SUBJECT: ISSUANCE OF AMENDMENTS FOR DIABLO CANYON NUCLEAR POWER PLANT,
UNIT NO. 1 (TAC NO. M91508) AND UNIT NO. 2 (TAC NO. M91509)

Amendment No. 104
License No. DPR-80

Amendment No. 103
License No. DPR-82

SAFETY EVALUATION BY THE OFFICE OF NUCLEAR REACTOR REGULATION
RELATED TO AMENDMENT NO. 104 TO FACILITY OPERATING LICENSE NO. DPR-80
AND AMENDMENT NO. 103 TO FACILITY OPERATING LICENSE NO. DPR-82
PACIFIC GAS AND ELECTRIC COMPANY
DIABLO CANYON NUCLEAR POWER PLANT, UNITS 1 AND 2
DOCKET NOS. 50-275 AND 50-323

FIGURE 3.9-2
 MINIMUM REQUIRED ASSEMBLY DISCHARGE BURNUP
 AS A FUNCTION OF INITIAL ENRICHMENT AND PELLETT DIAMETER TO PERMIT
 STORAGE IN REGION 2

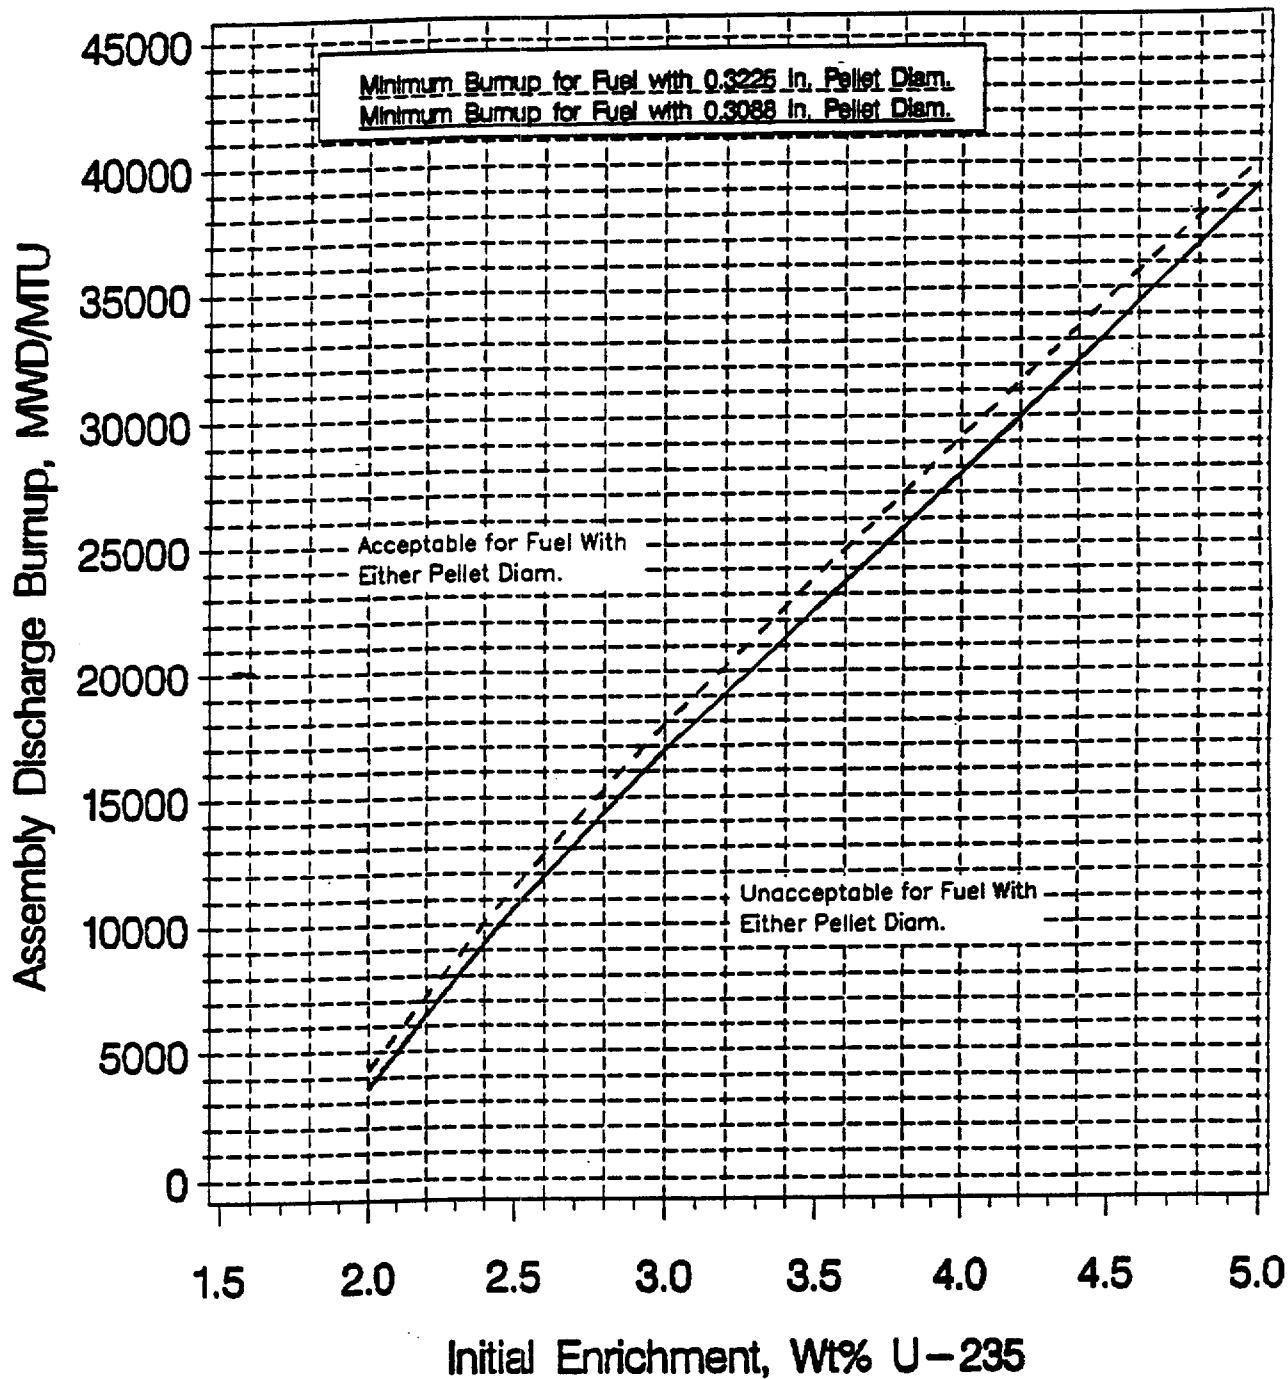
- (1) TS 3.9.14.1 and Figure 3.9-2 have been revised to allow the storage of spent fuel assemblies with initial enrichments up to 5.0 wt% U-235 in Region 2 of the spent fuel pool. Fuel pellet diameters are considered in combination with initial enrichment and cumulative burnup to encompass both Westinghouse standard and OFA fuel.

3.9.14.1 The combination of initial enrichment, pellet diameter, and cumulative burnup for spent fuel assemblies stored in Region 2 shall be within the acceptable area of Figure 3.9-2.

FIGURE 3.9-3
MINIMUM REQUIRED ASSEMBLY DISCHARGE BURNUP
AS A FUNCTION OF INITIAL ENRICHMENT (NO IFBA) TO PERMIT
STORAGE IN REGION 1

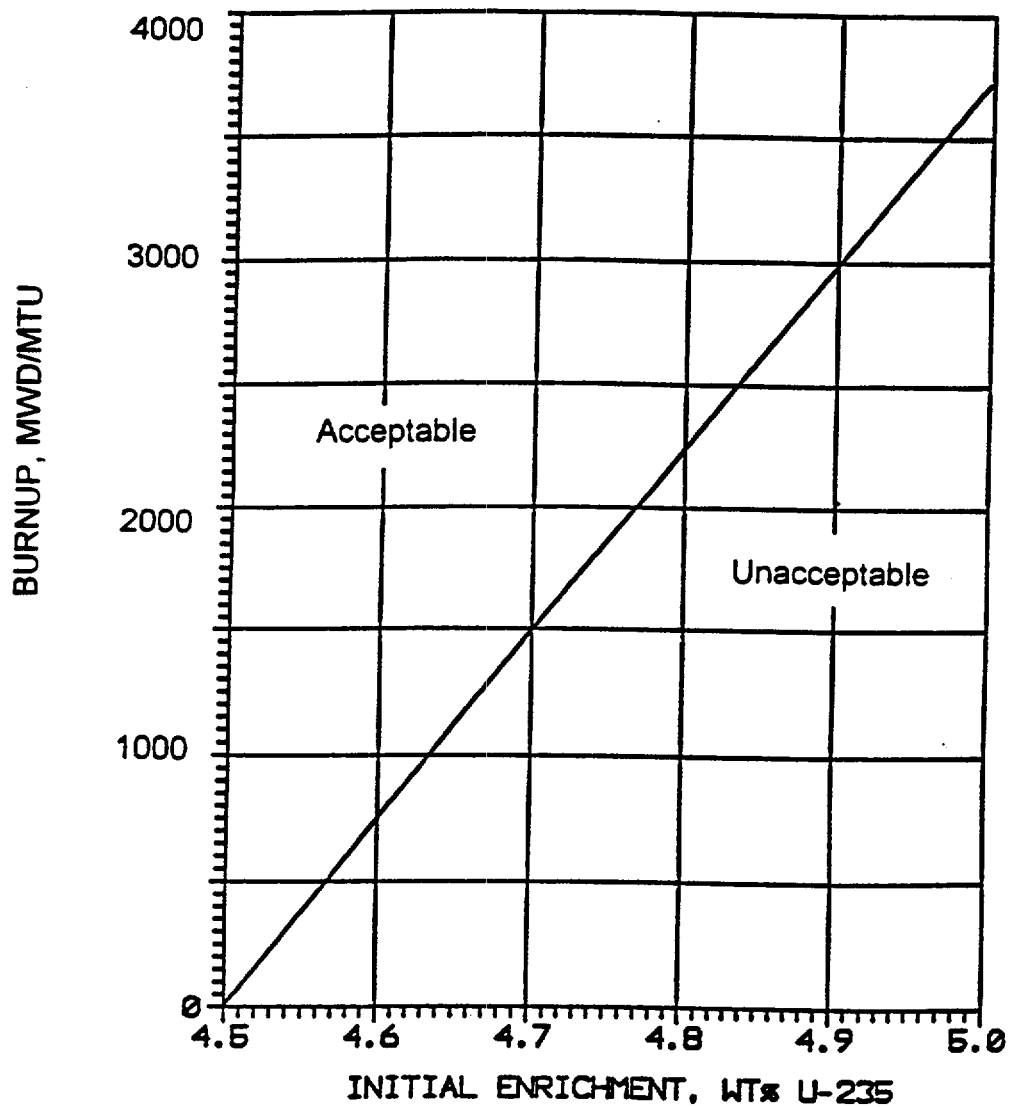
- (2) TS 3.9.14.3 and Figure 3.9-3 have been added to include the requirements for acceptable fuel storage in Region 1. In addition, an action statement is included requiring suspension of all fuel movement and crane operations except to move the non-complying assemblies into an acceptable pattern.

- a. The initial enrichment is 4.5 weight percent U-235 or less; or
- b. The initial enrichment is from 4.5 up to a maximum of 5.0 weight percent U-235, and any of the following conditions are met:
 - 1) The combination of initial enrichment and cumulative burnup of the assemblies is within the acceptable area of Figure 3.9-3; or
 - 2) The assemblies initially contained a minimum of a nominal 36 mg/in. per assembly of the isotope B-10 integrated in the fuel rods; or
 - 3) The assemblies are put in a checkerboard pattern with any of the following:
 - a) water cells, or
 - b) assemblies that initially contained a minimum of a nominal 72 mg/in. per assembly of the isotope B-10 integrated in the fuel rods, or
 - c) partially irradiated fuel of at least 8000 MWD/MTU cumulative burnup; or
 - 4) The assemblies are put into a pattern with alternate rows of fuel assemblies and water cells.
